WATERVUE

643-651 HUNTER STREET NEWCASTLE NSW 2300

DEVELOPMENT APPLICATION SHEET LIST		
DRAWING NO.	TITLE	REVISION
DA000	PLAN - LOCATION & DRAWING SCHEDULE	F
DA002	SITE ANALYSIS	B
DA003	PREDICT LOCATION PLAN	C
DA005	SITE PLAN	B
DA006	SHADOW DIAGRAMS	B
DA007	SHADOW DIAGRAMS	B
DA008	SHADOW DIAGRAMS	A
DA009	SOLAR ACCESS DIAGRAM	B
DA010	VENTILATION DIAGRAMS	B
DA011	PLANNING - GFA	C
DA012	UNIT AREA FOR CARPARKING GEN.	B
DA101	GROUND FLOOR	E
DA102	PARKING LEVEL 1	D
DA103	PARKING LEVEL 2	C
DA104	PARKING LEVEL 3	C
DA105	PLAN - PODIUM	E
DA106	PLAN - TYPICAL LOWER	D
DA107	PLAN - TYPICAL UPPER	C
DA111	PLAN - PENTHOUSES	B
DA112	ROOF	B
DA200	STREETSCAPE ELEVATIONS	B
DA201	ELEVATIONS - NORTH AND EAST	F
DA202	ELEVATIONS - SOUTH AND WEST	C
DA301	SECTIONS	C
DA321	RAMP SECTION CARPARK	C
DA401	PERSPECTIVE	B
DA402	PERSPECTIVE	B
DA403	PERSPECTIVE	B
DA409	MATERIALS + FINISHES	B
DA801	PODIUM LEVEL PRIVACY SCREENS	A
DA802	SIGNAGE DESIGN INTENT	A

DRAWING No. **DA301**
DRAWING TITLE **SECTIONS**
SCALE **1 : 200 @ A1**
DATE **2022**

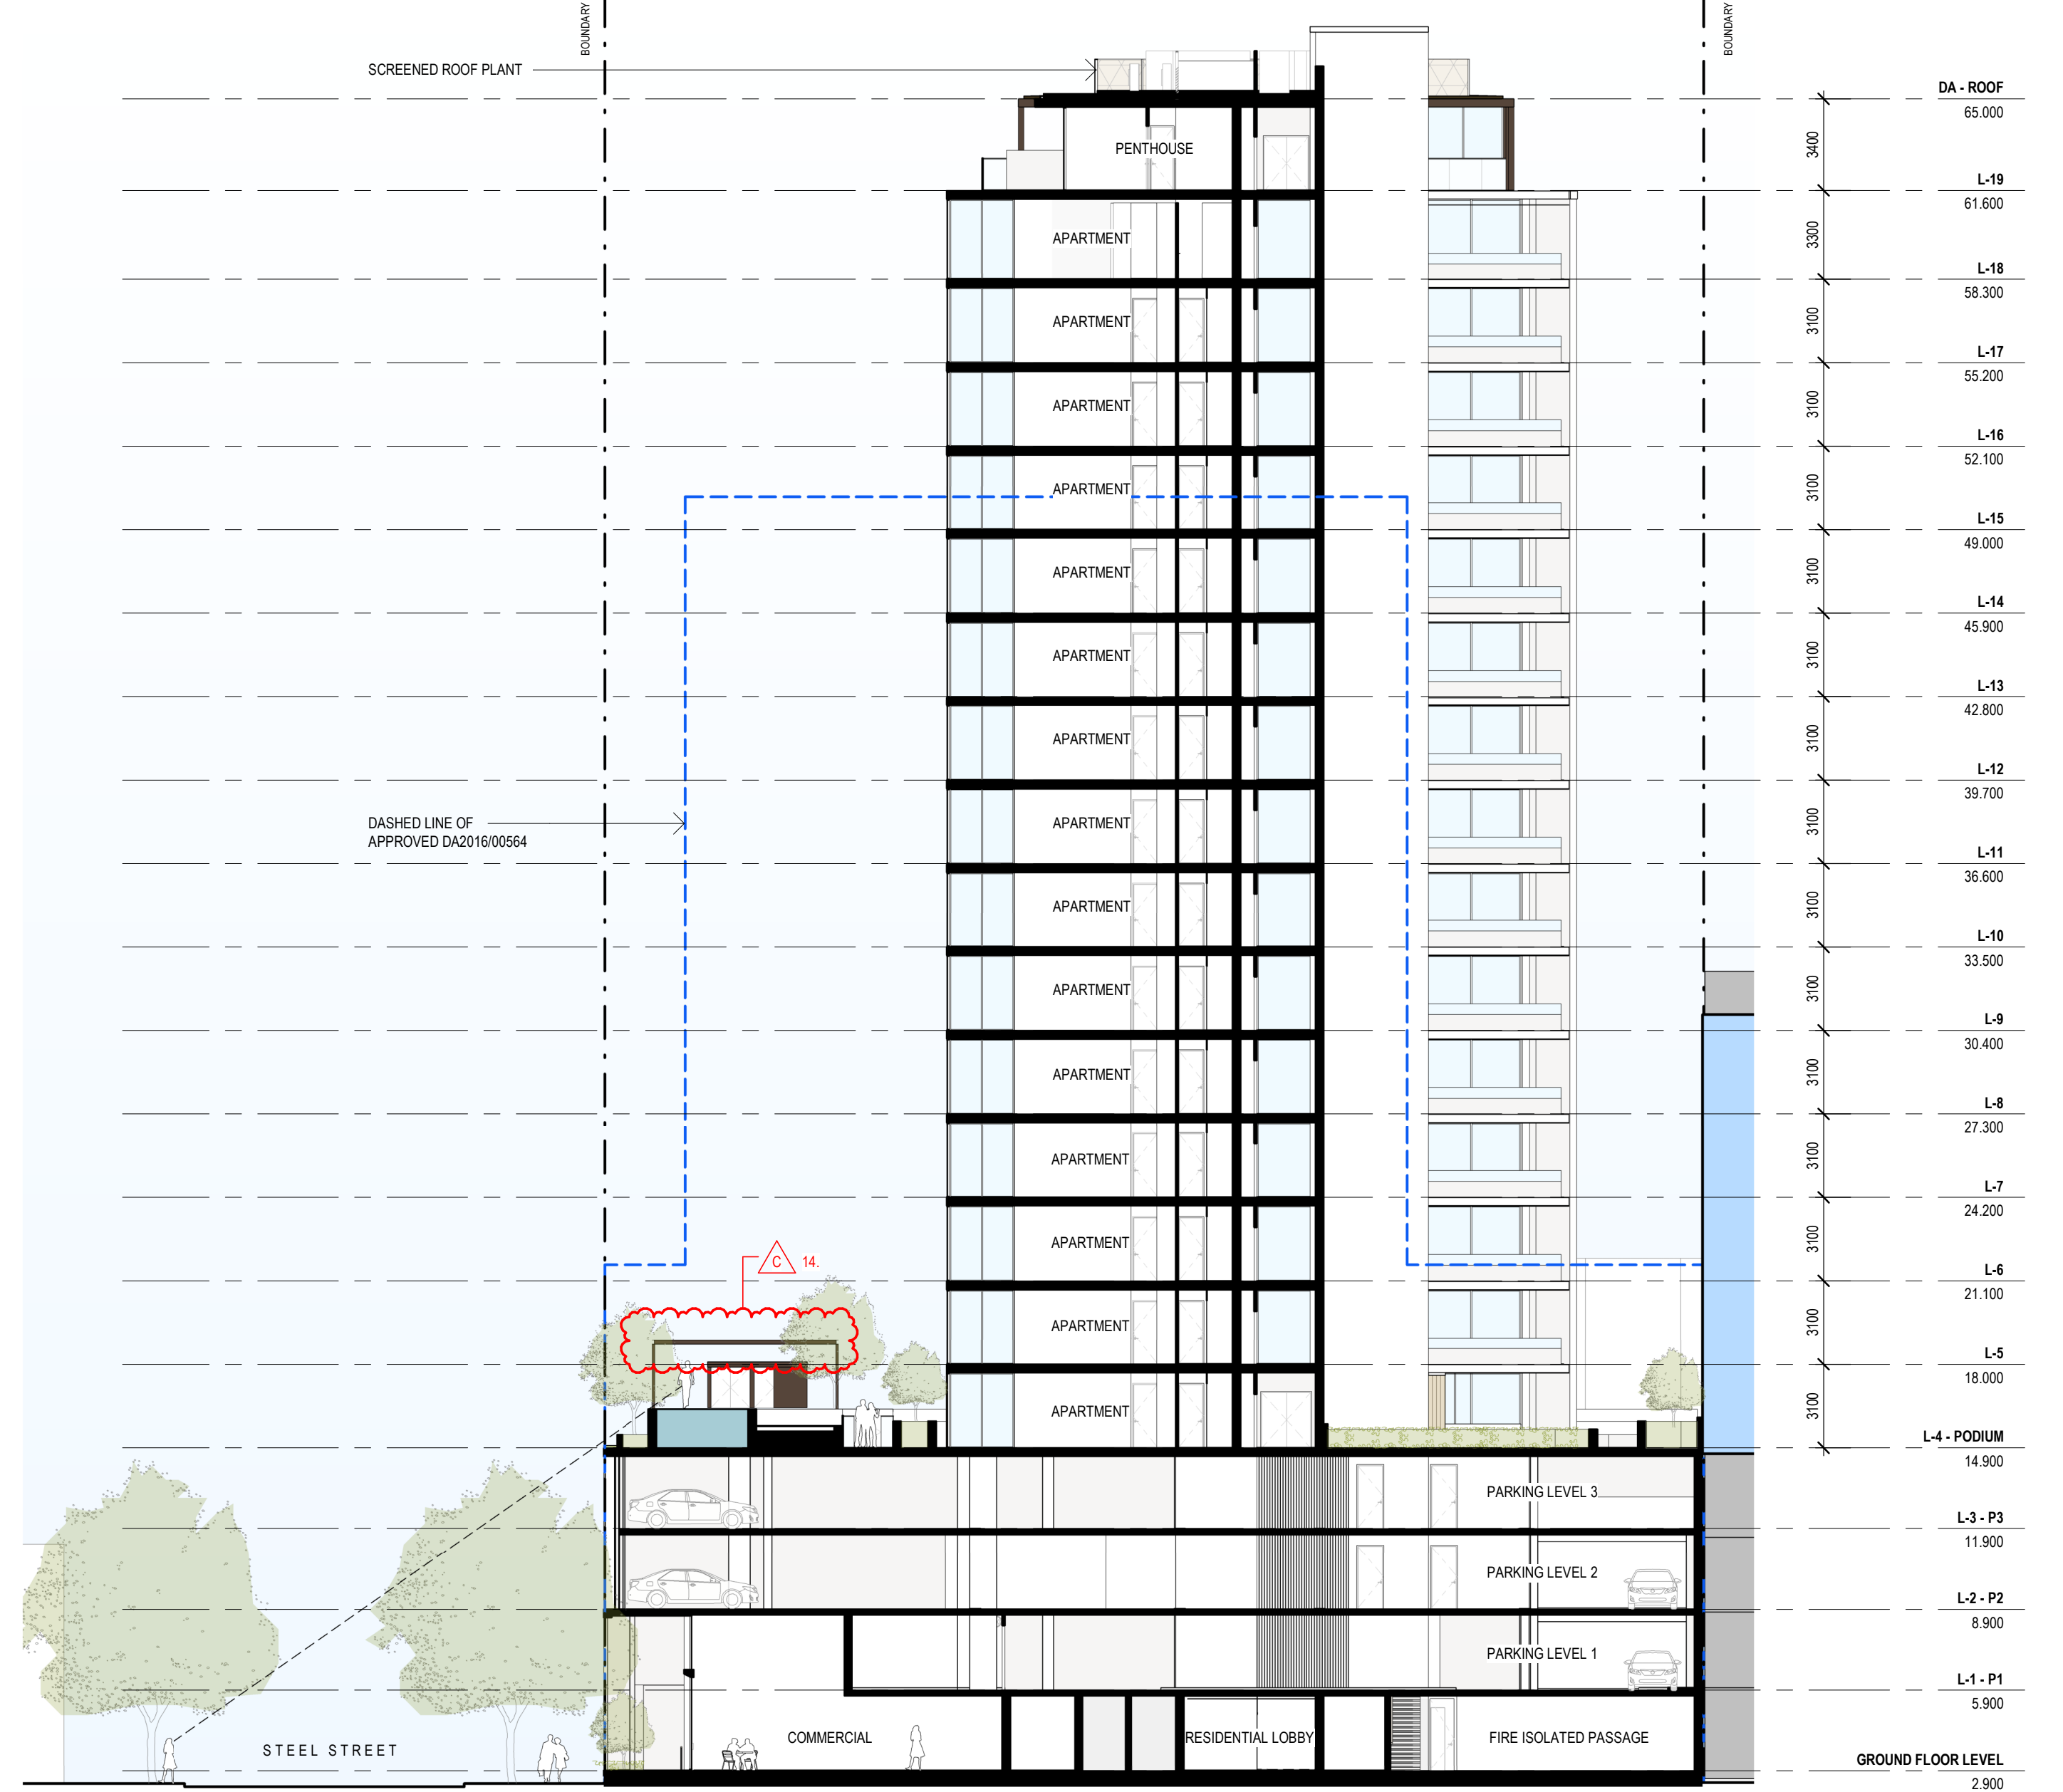
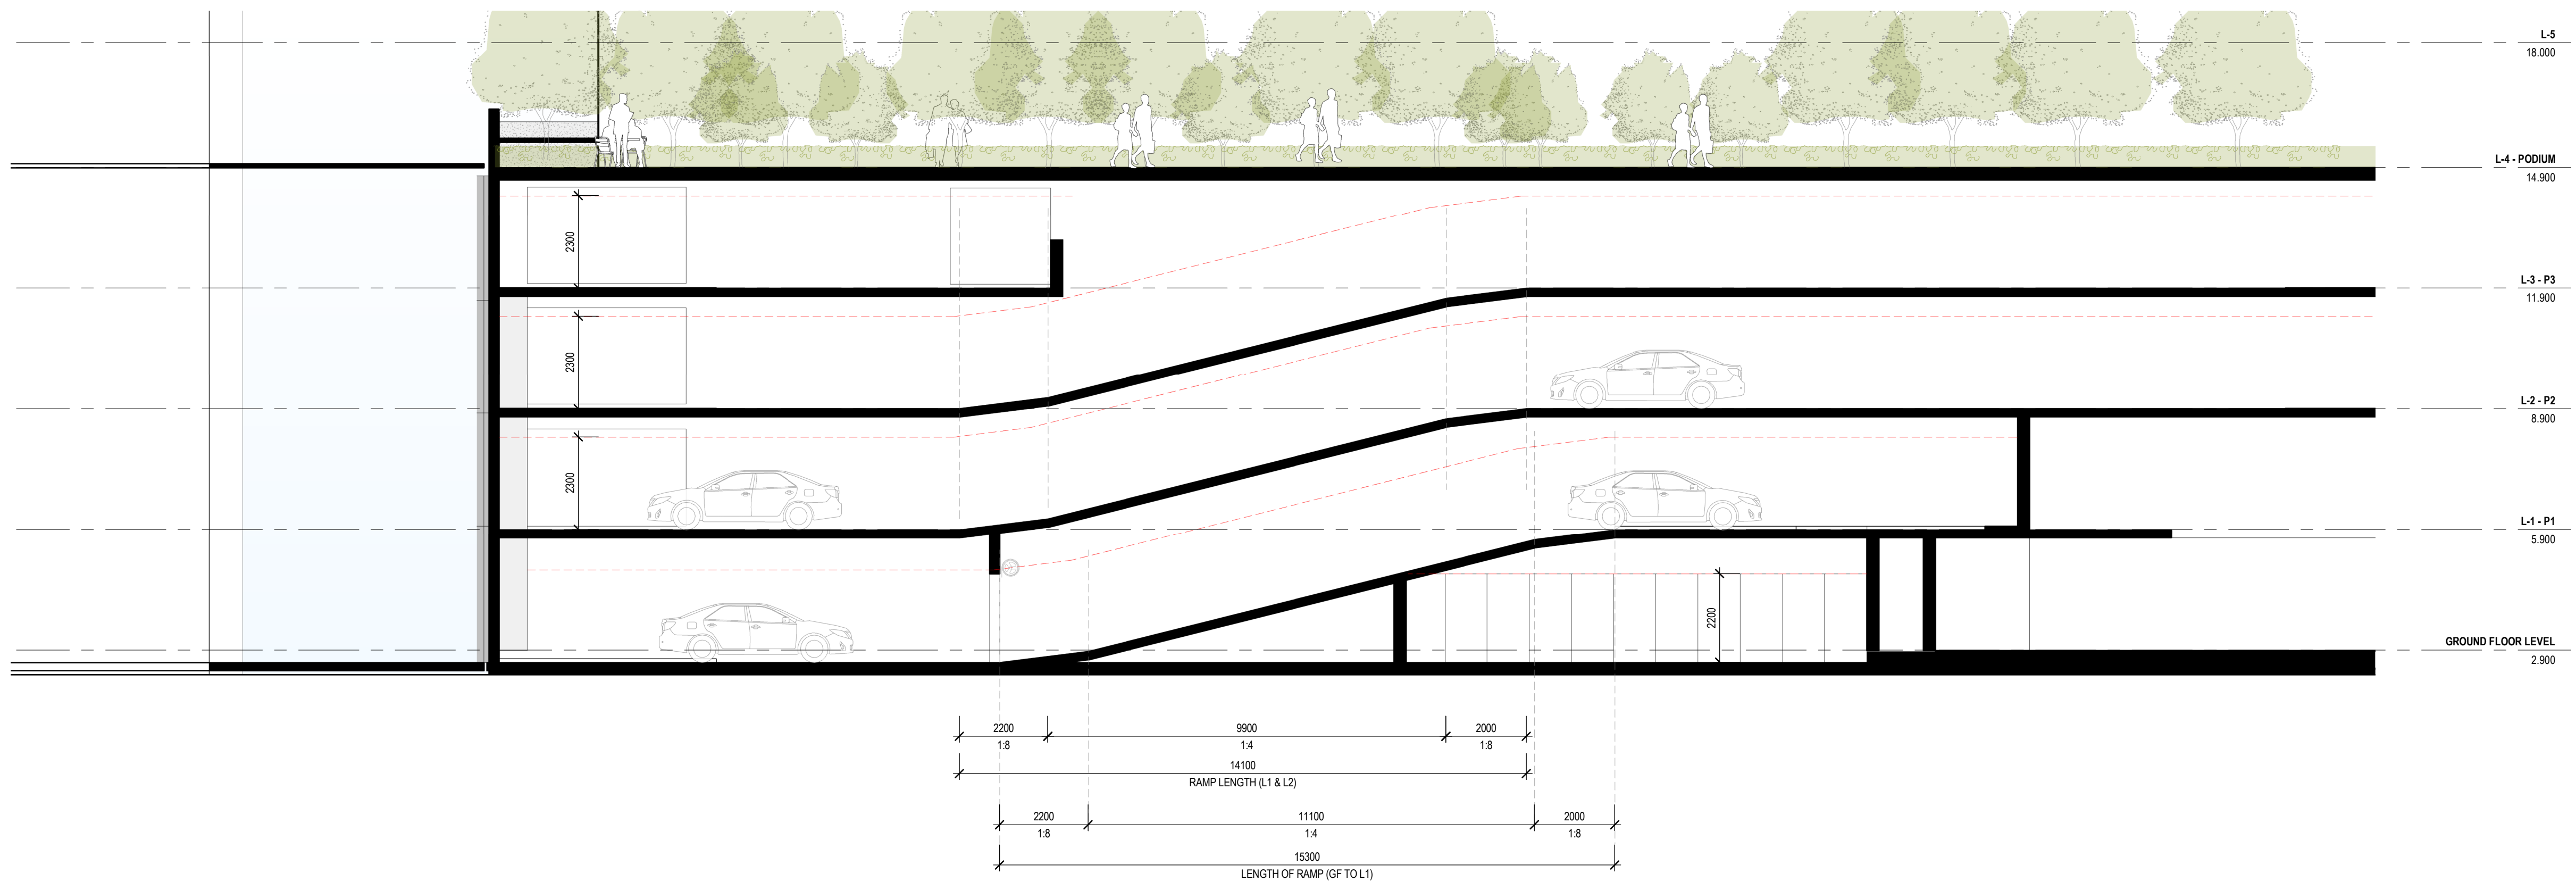
1. GROUND FLOOR CARPARKING LEVEL LOWERED BY 300MM
2. DRIVEWAY GRADES UPDATED TO SUIT UPDATED PARKING LEVEL
3. DOOR TO FIRE EGRESS CORRIDOR RELOCATED
4. STEP ADDED TO FIRE EGRESS PATH TO SUIT UPDATED PARKING LEVEL
5. STEPS AND PLATFORM ADDED TO MSB ROOM TO SUIT UPDATED PARKING LEVEL
6. MAIL ROOM ADDED TO RESIDENTIAL LOBBY
7. MAILBOXES RELOCATED INTO THE RESIDENTIAL LOBBY
8. MOTORCYCLE SPACE DISTRIBUTION ACROSS L1, L2 AND L3 UPDATED (TOTAL REMAINS THE SAME)
9. SECURE ENTRY ADDED AT BASE OF RESIDENTIAL CARPARK RAMP GF TO L1 RAMP LENGTH UPDATED TO SUIT UPDATED GROUND FLOOR PARKING LEVEL
10. GARAGE ADDED TO L1 AND L2
11. STORAGE CAGE ARRANGEMENT UPDATED
12. LANDSCAPE COURTYARD ACCESS DOOR ADDED TO PODIUM LEVEL
13. POOL PERGOLA SHOWN IN ELEVATION
- 14.

DRAWING No. **DA321**
DRAWING TITLE **RAMP SECTION CARPARK**
SCALE **1:100 @ A1**
DATE **2022**

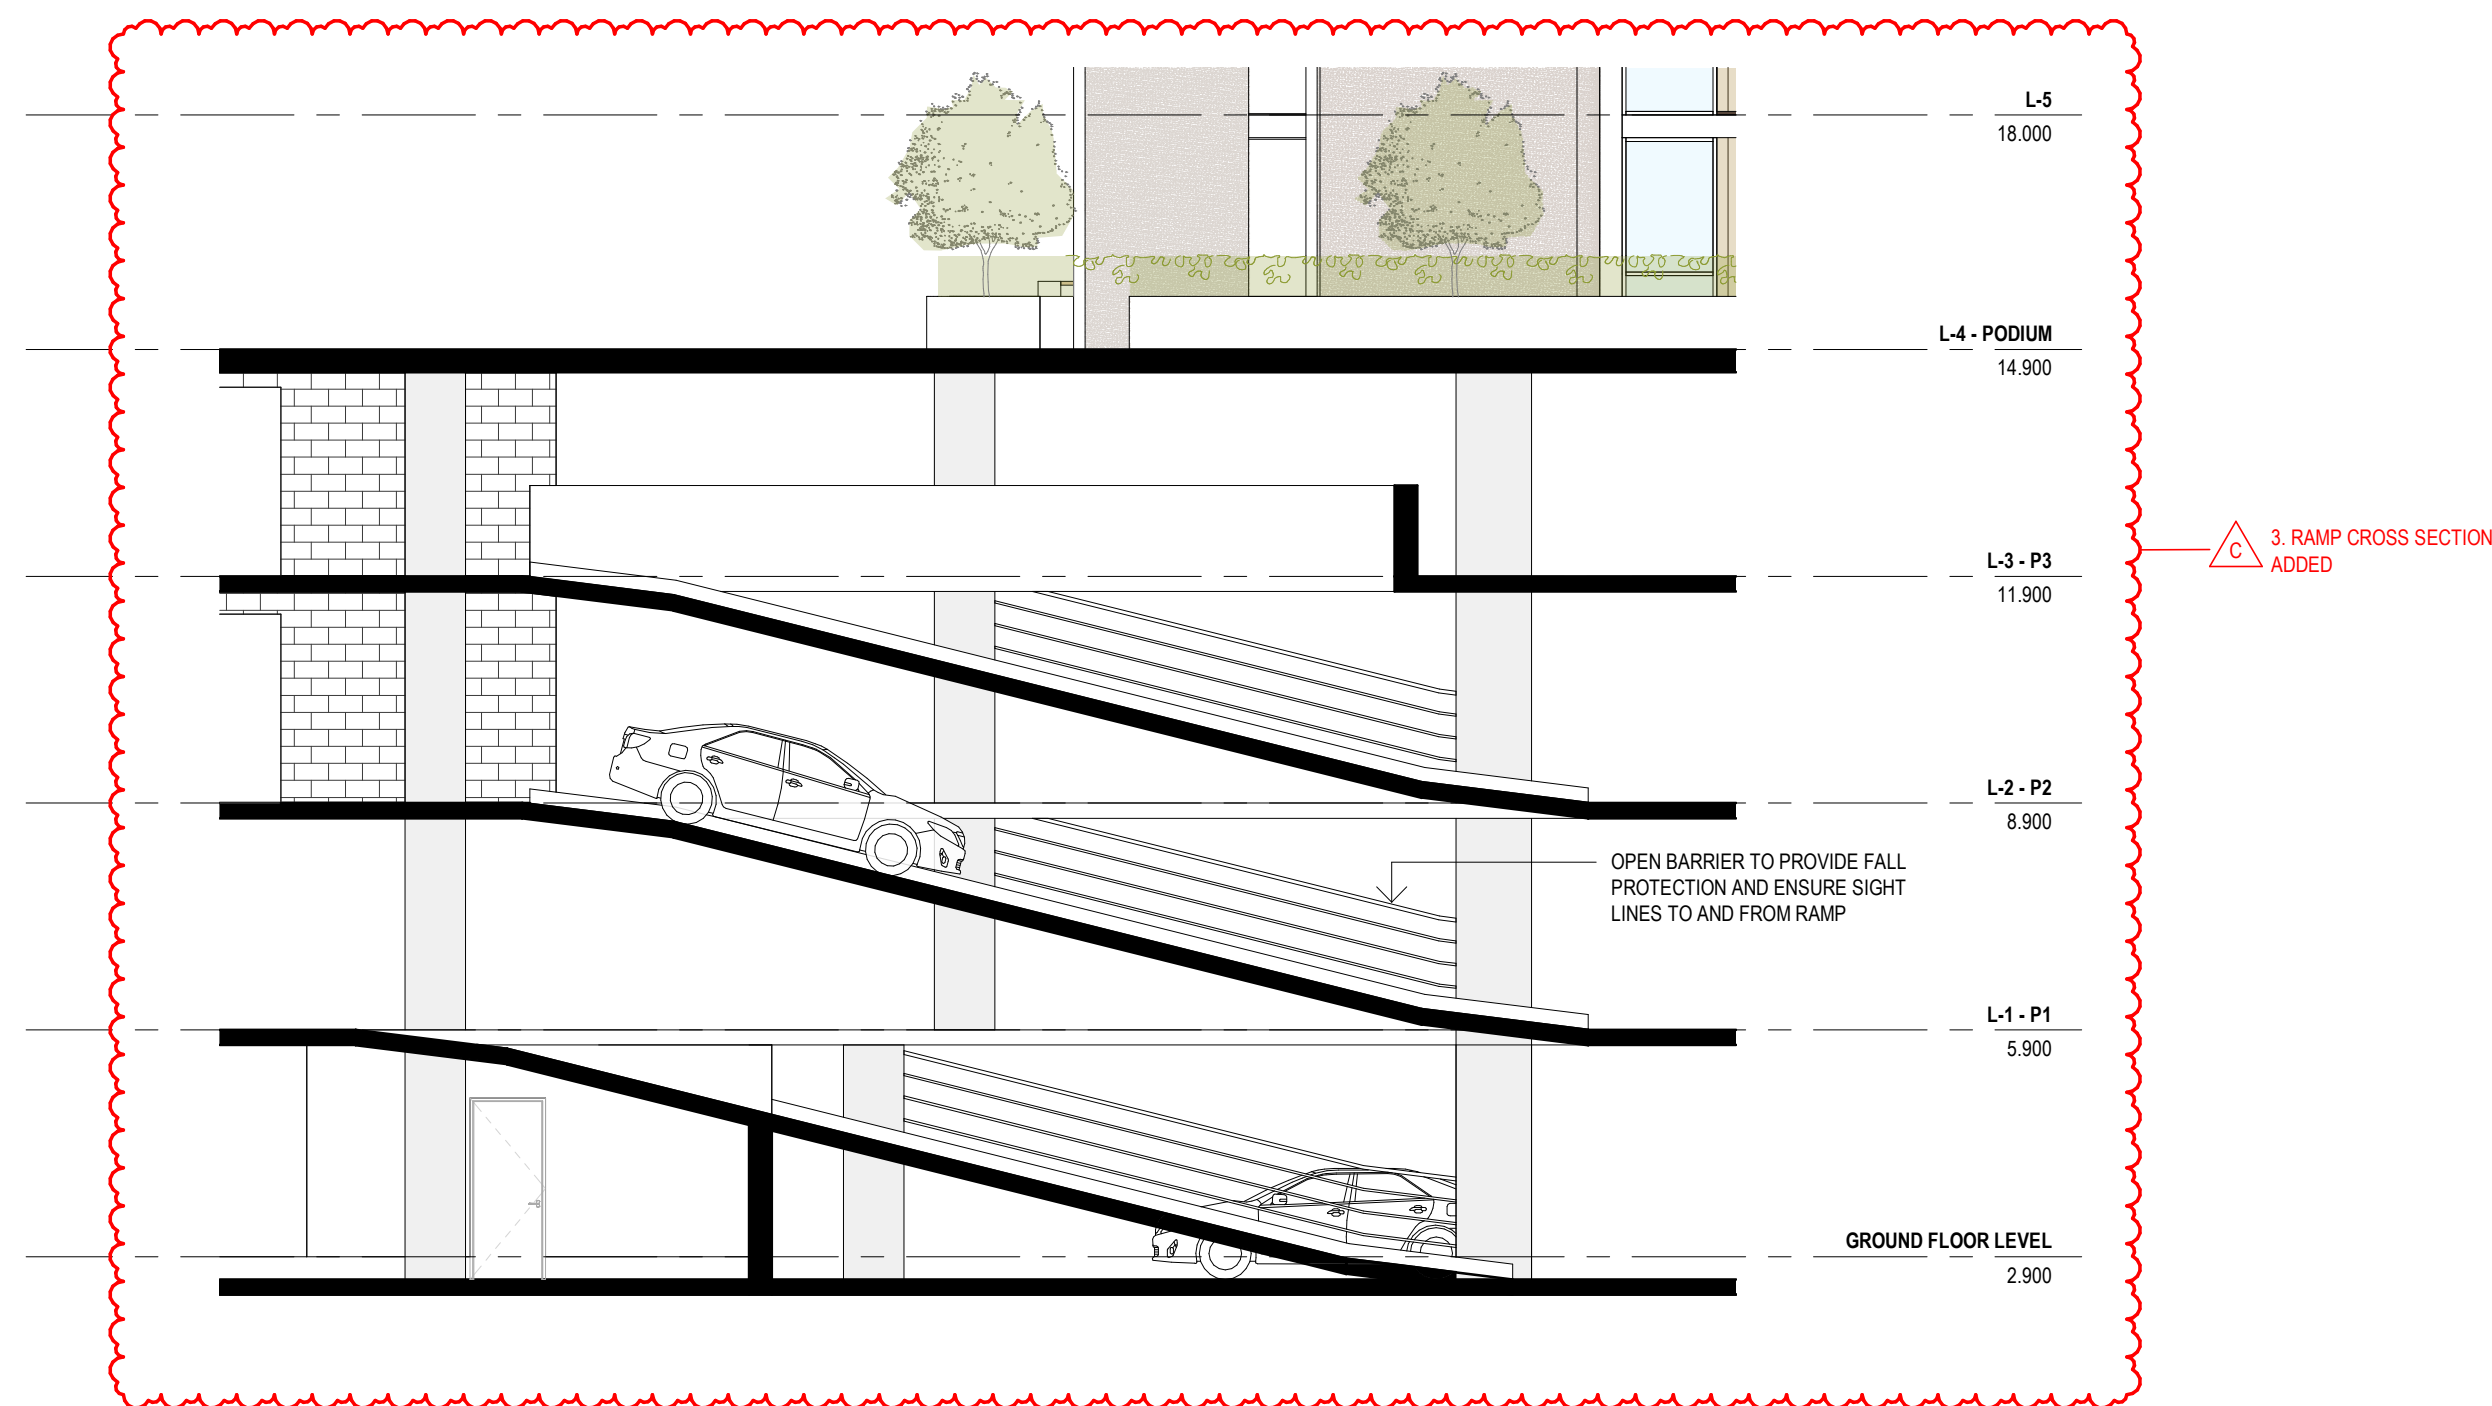
1. NOTCHES IN AWNING ADDED
2. FUTURE STREET TREE CLEARANCE INDICATED
3. ADDITIONAL RAMP SECTION PROVIDED
4. RAMP EDGE CONDITION CLARIFIED
5. COMMERCIAL TENANCY STORAGE, WIC'S, COMMS ROOM, MAIL ROOM RECONFIGURED TO CREATE FLOOD EVACUATION PATH
6. STAIRS REMOVED
7. STAIRS REMOVED RAMP ADDED
